STAFF REPORT
KETCHUM PLANNING AND ZONING COMMISSION
REGULAR MEETING OF JUNE 25, 2024

PROJECT: Papillon Condos (formerly Bohica Mixed-Use)

APPLICATION TYPE: Design Review Amendment

REQUEST: Design Review amendment for revisions to the front façade of the building along N Washington Ave.

A-200

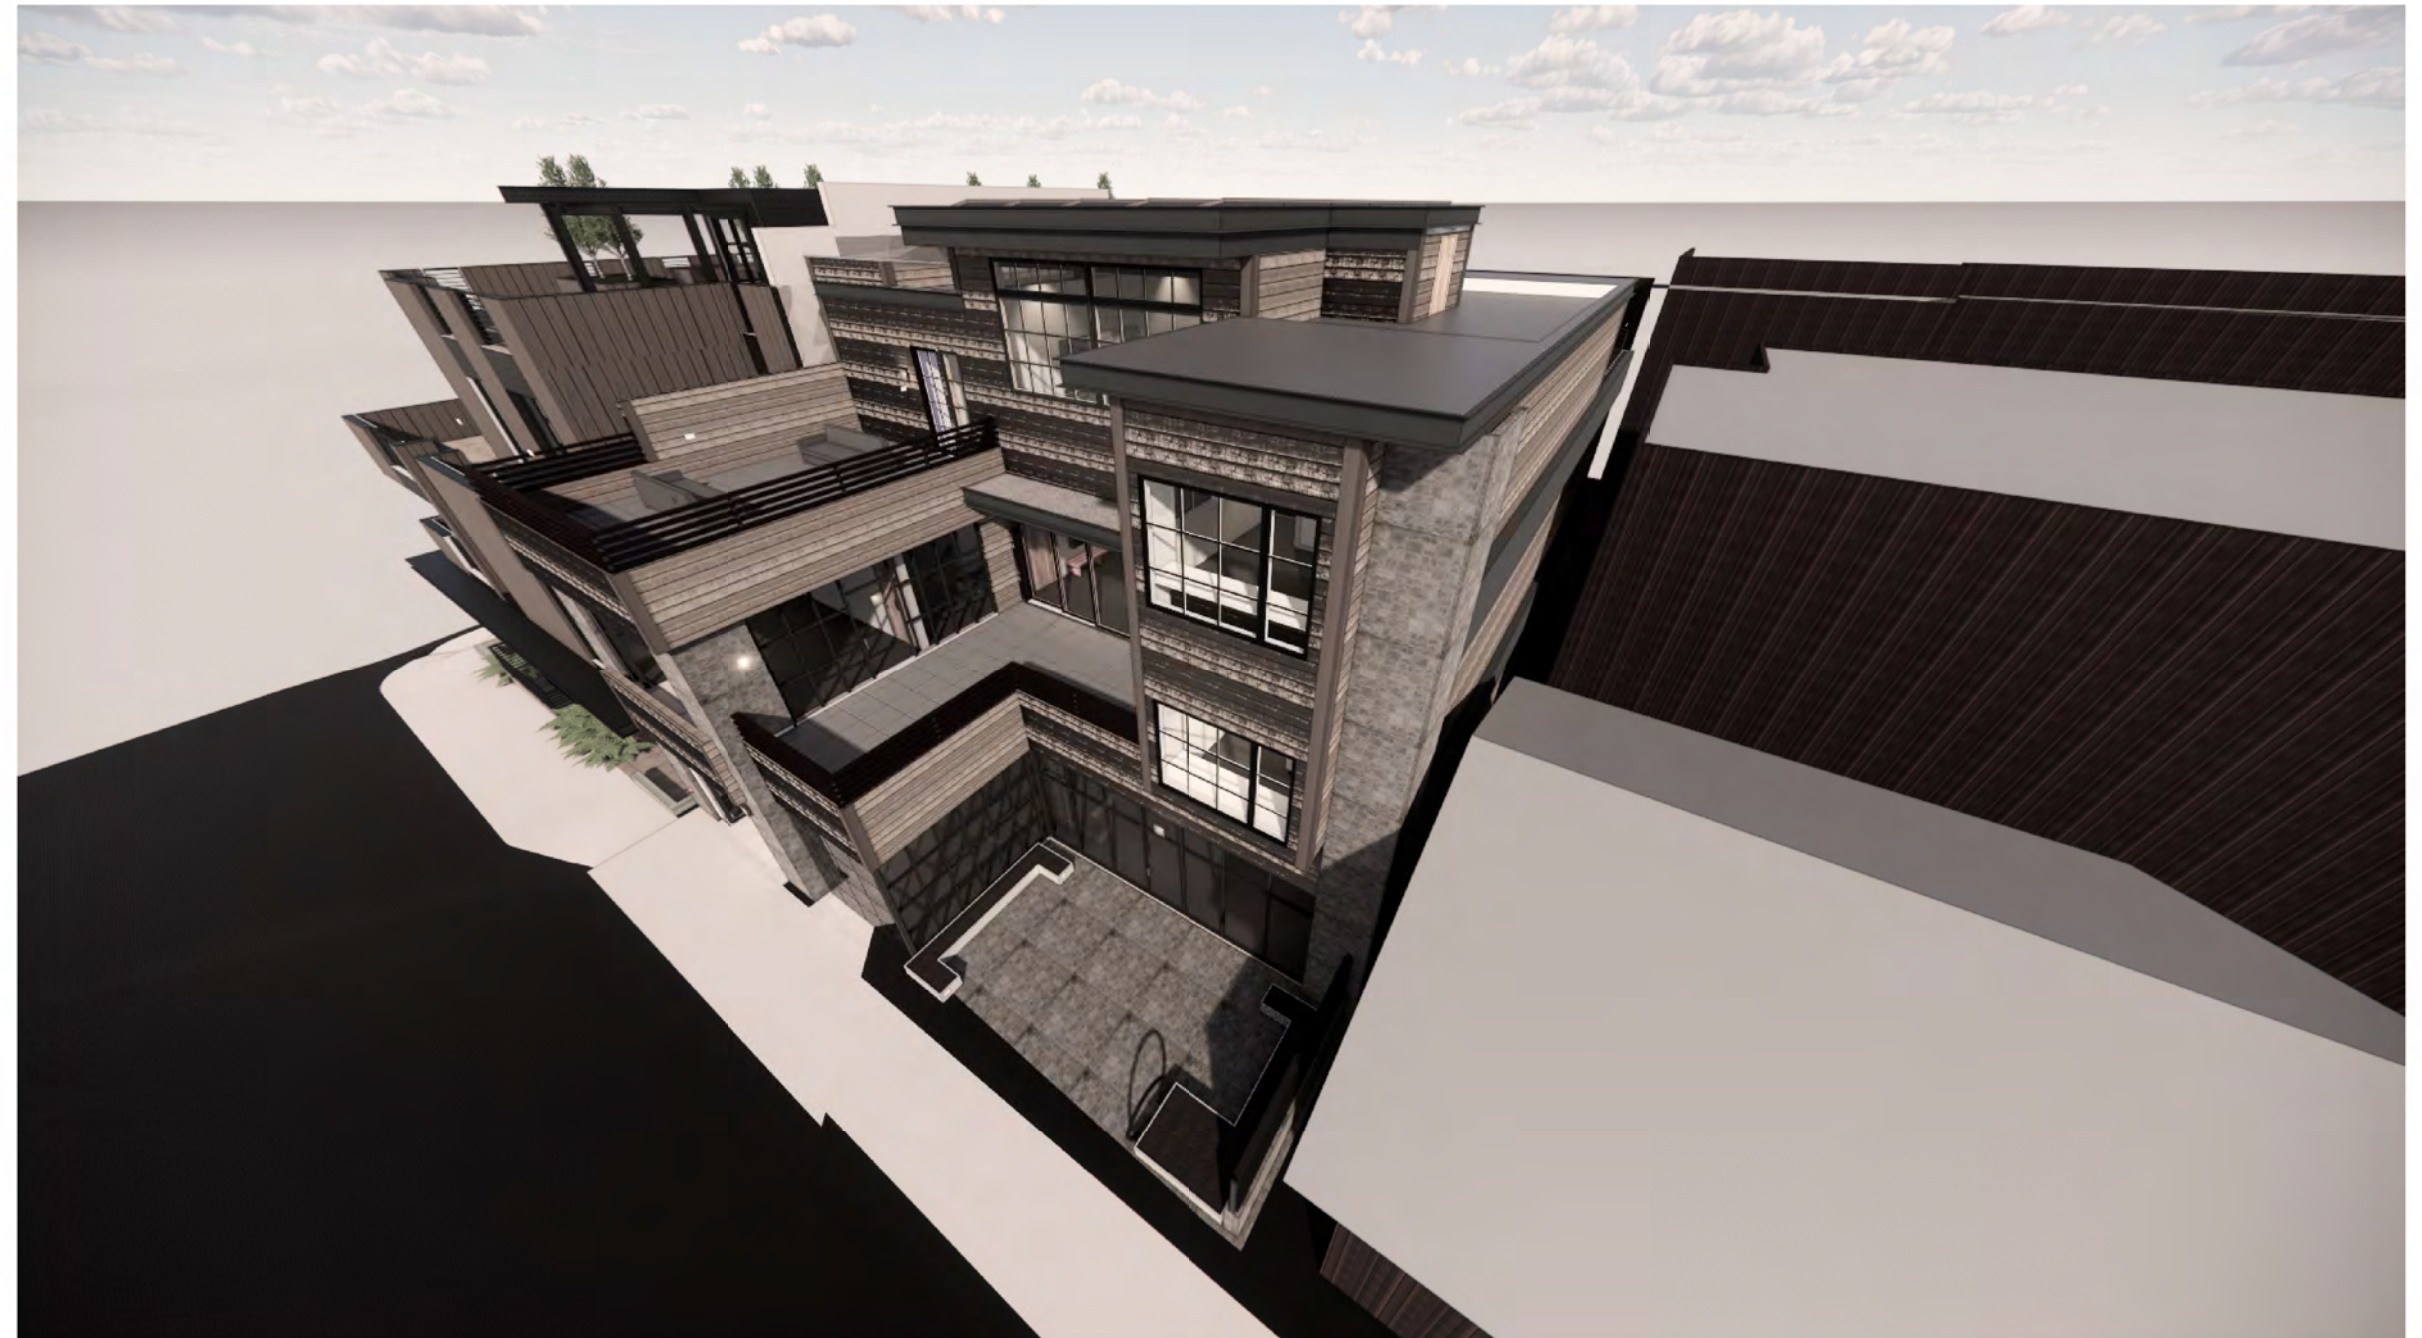
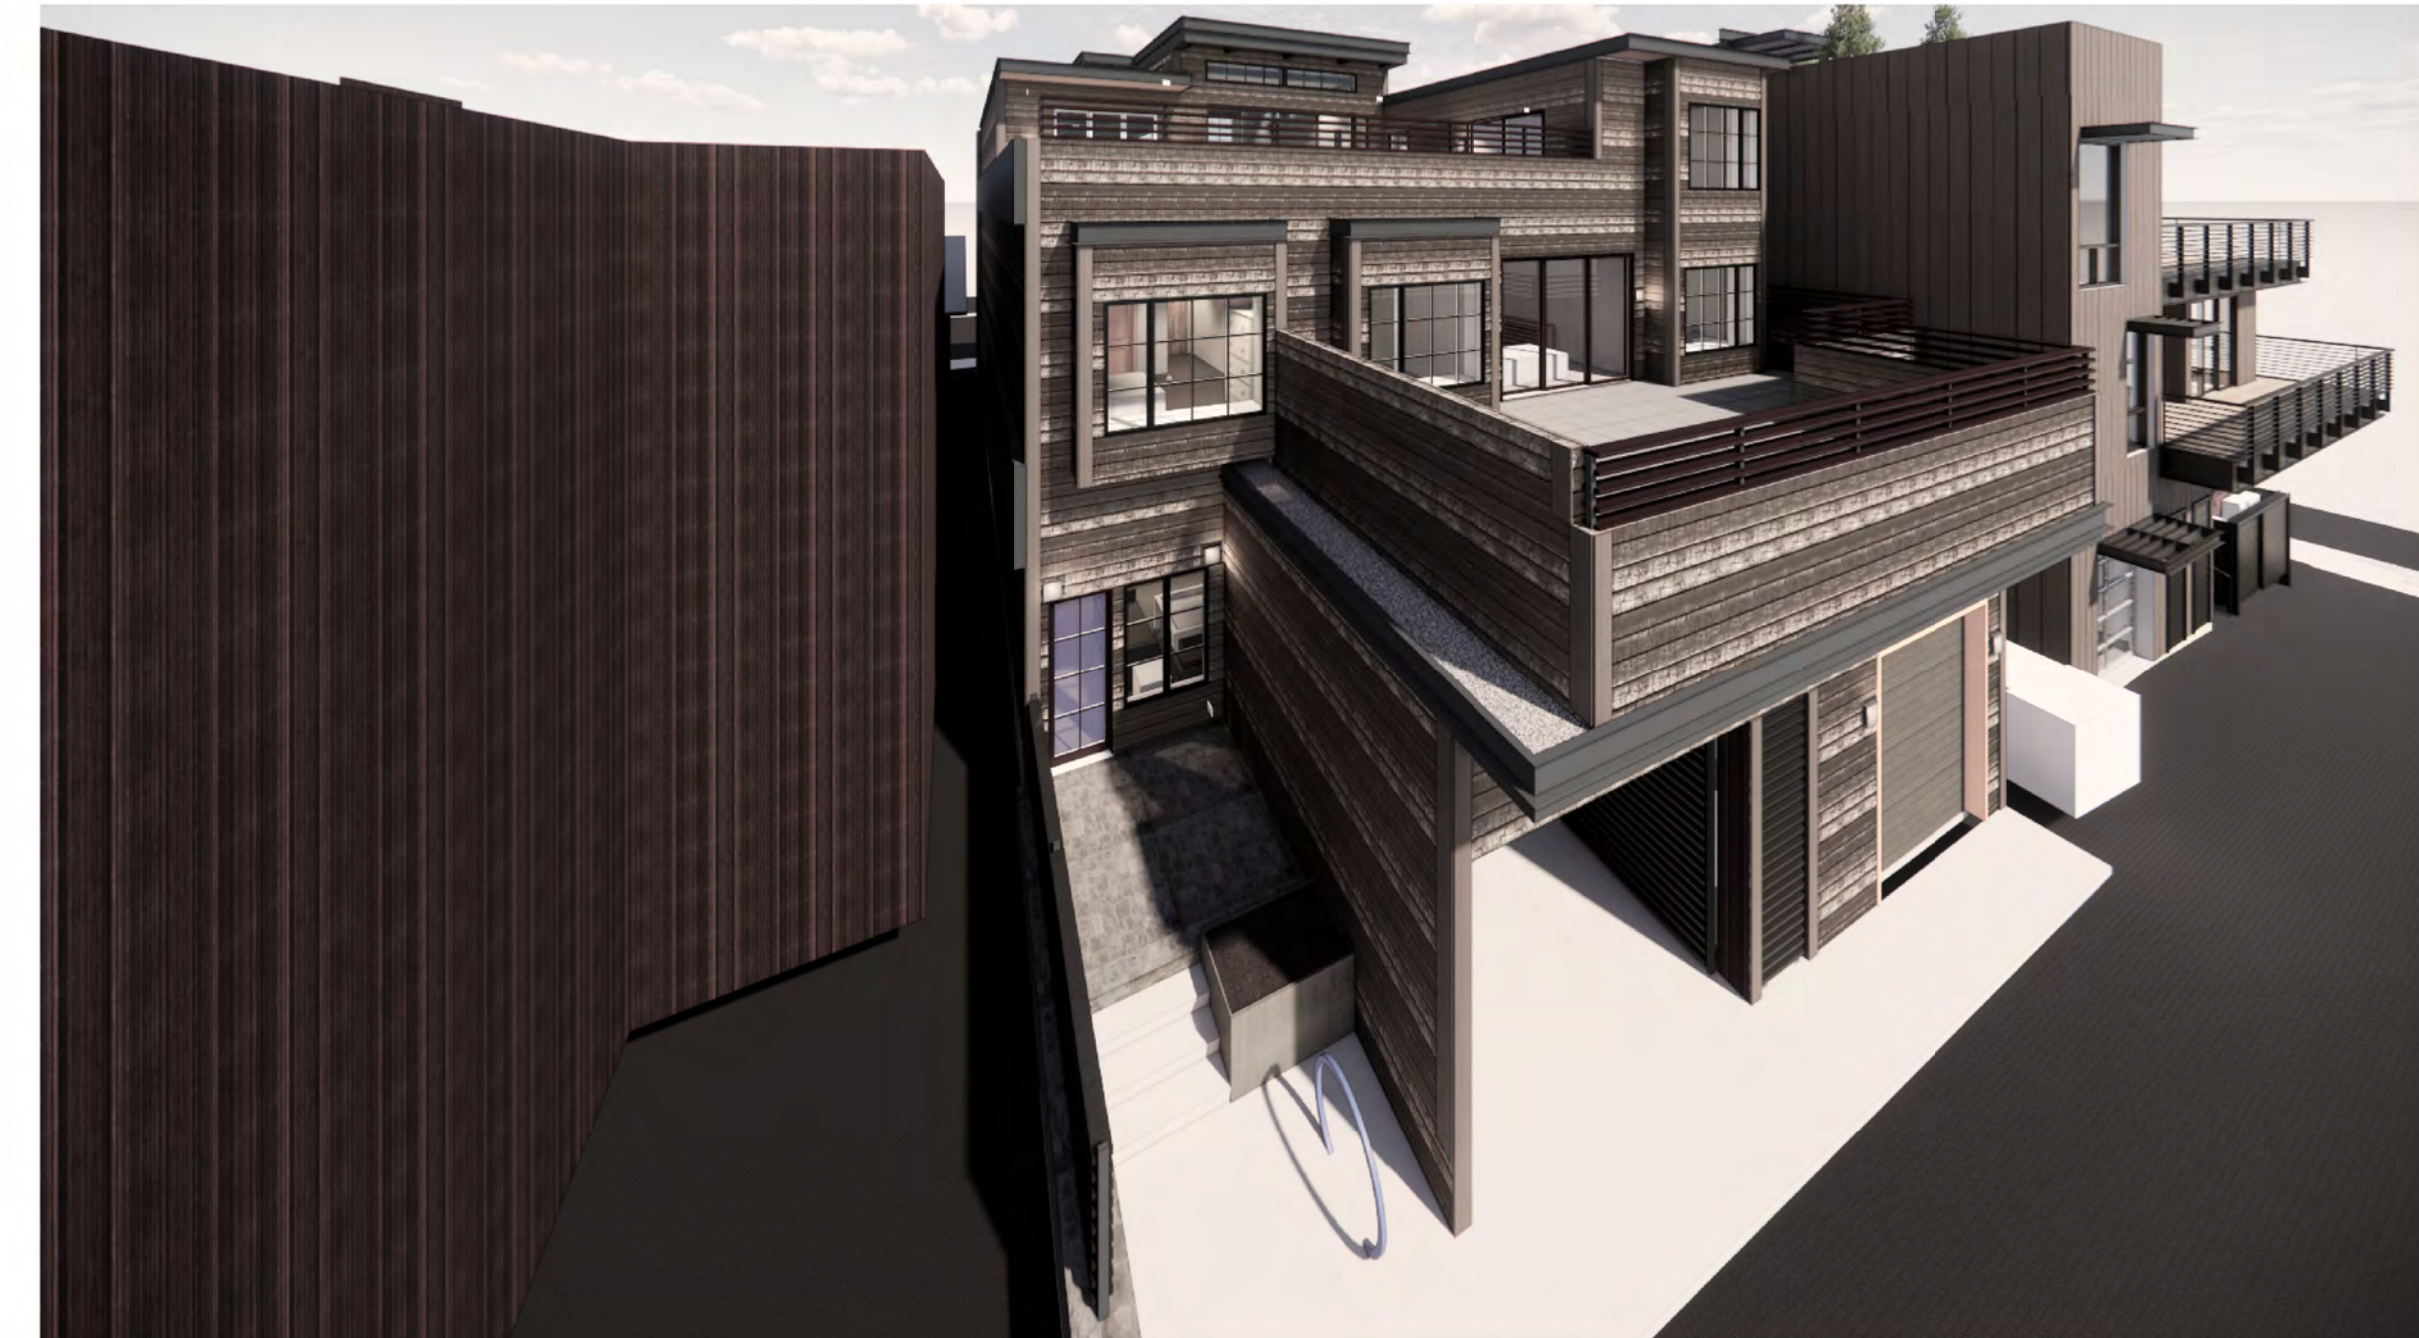
Horizontal siding and vertical corner boards added to rendering

1 housing patio
 A-200a 12" = 1'-0"

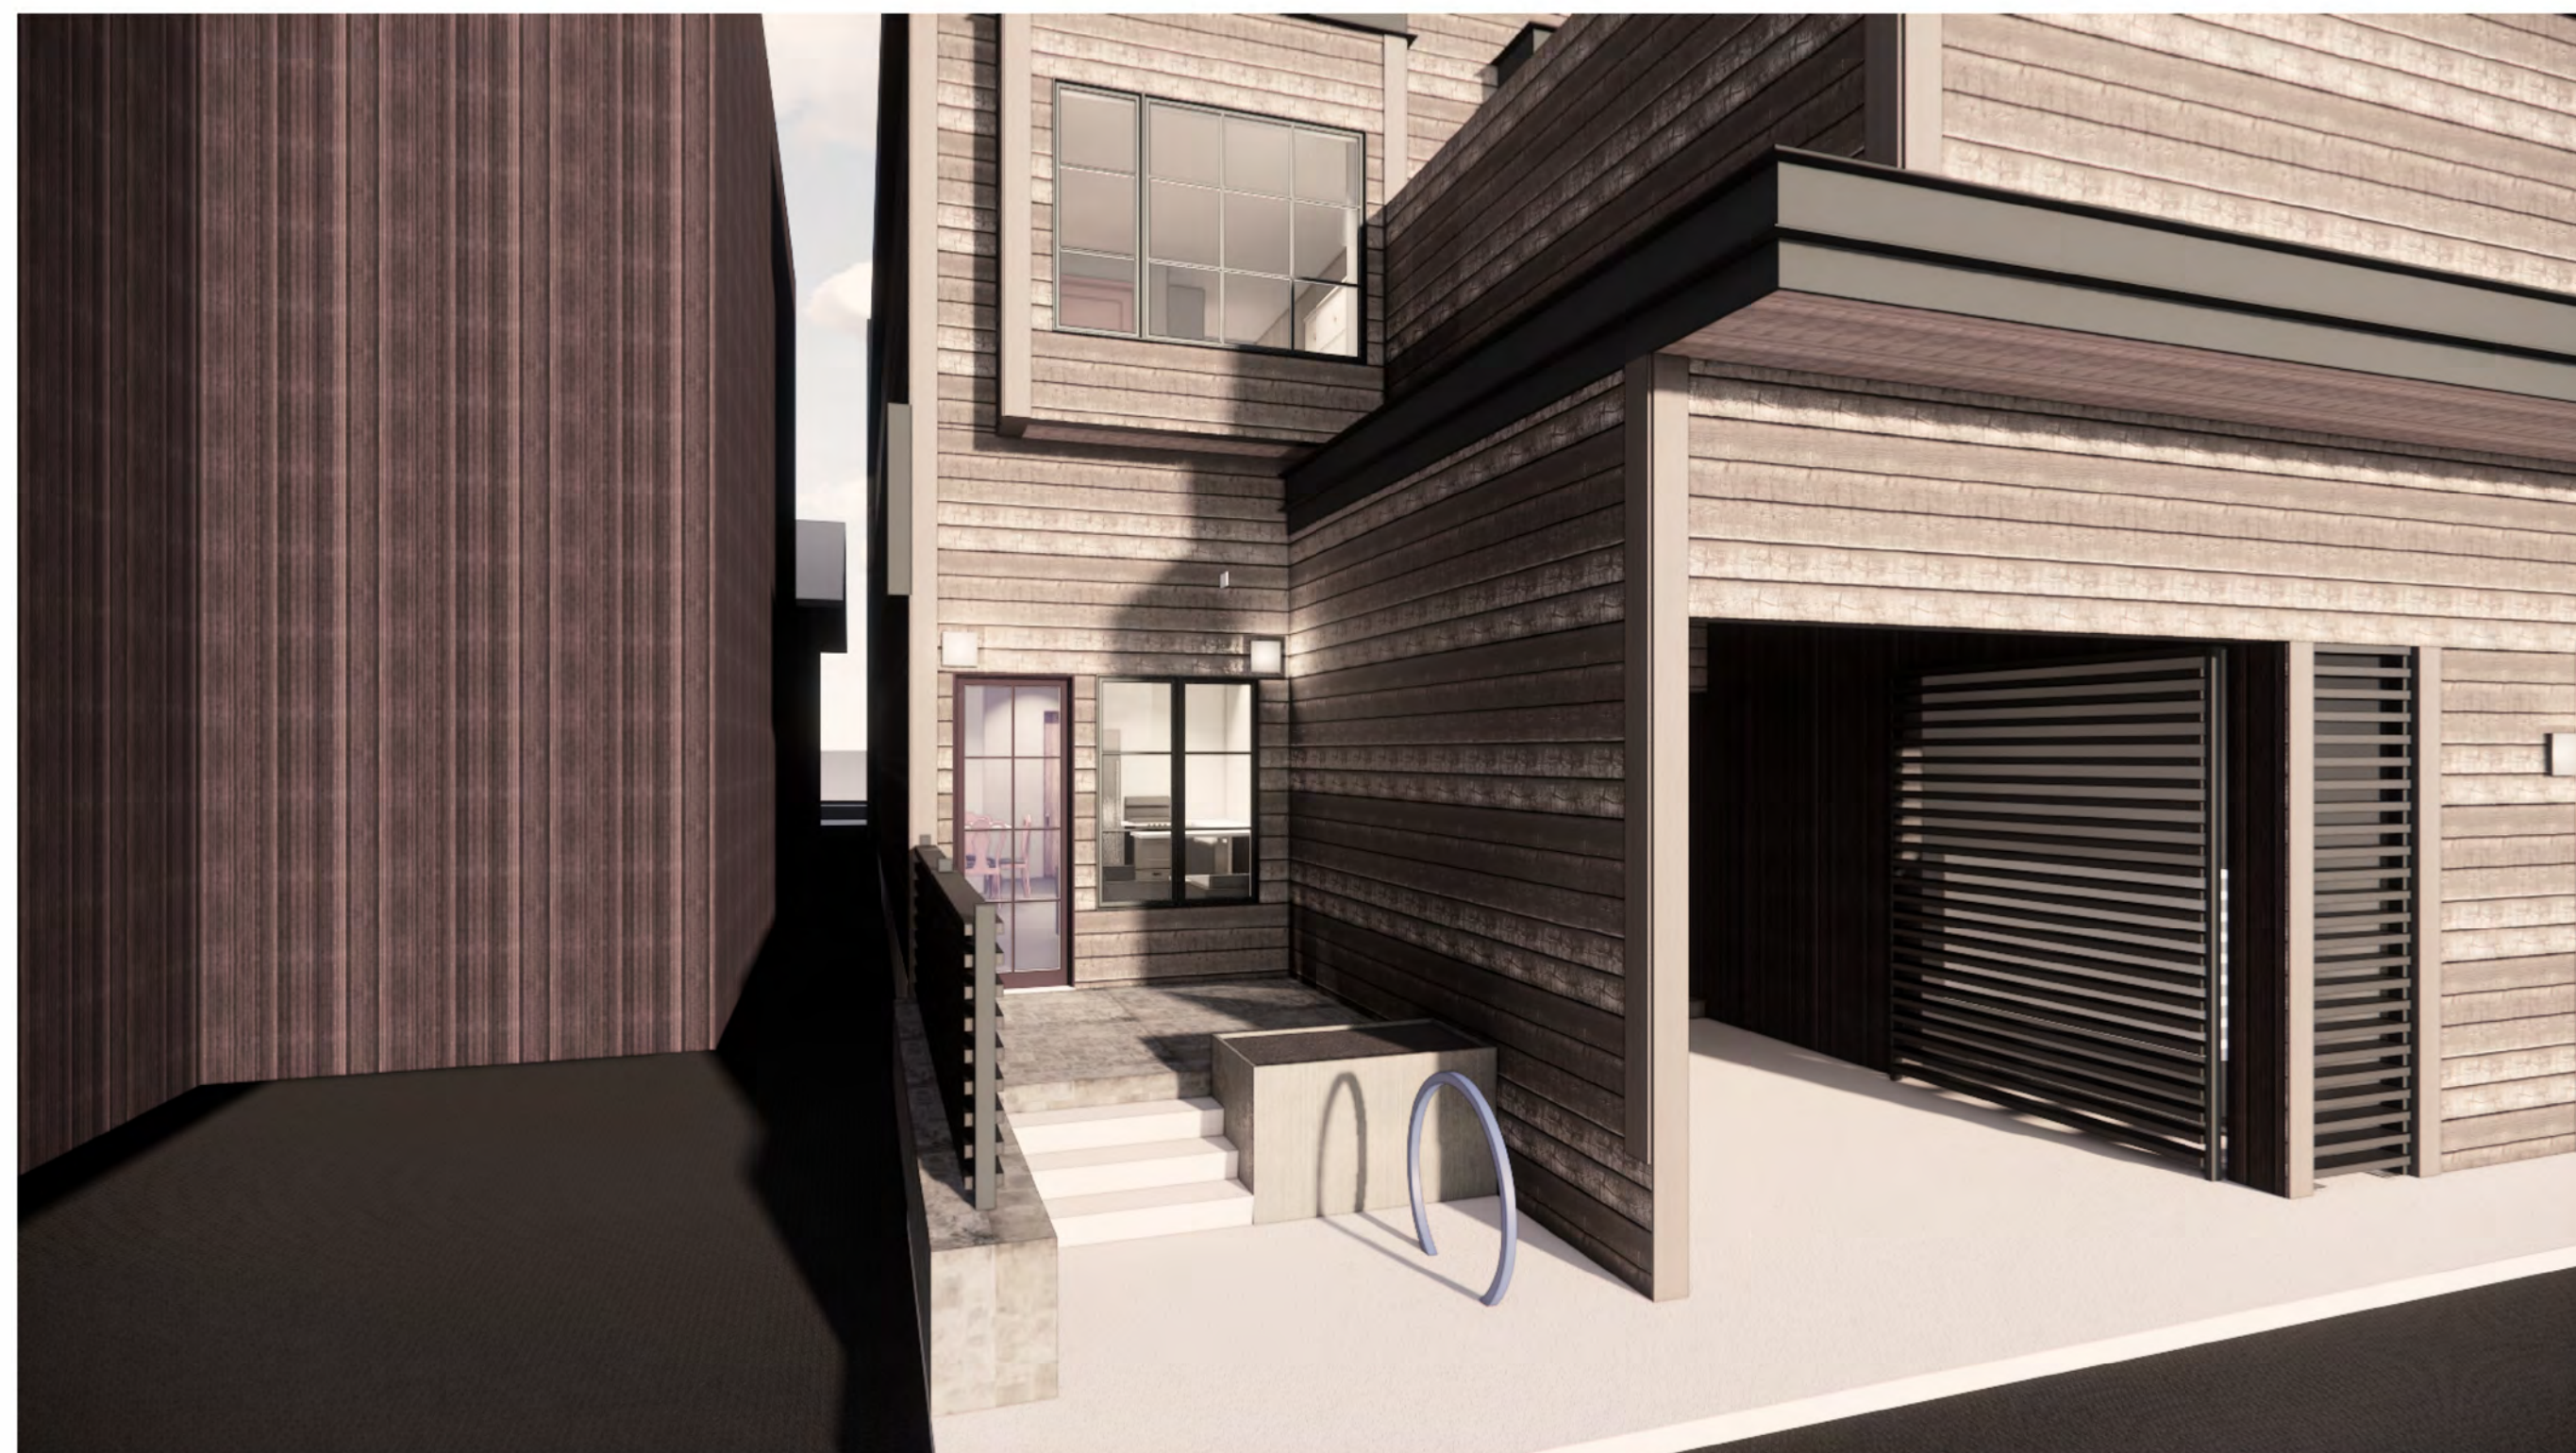
Horizontal siding and vertical corner boards added to rendering
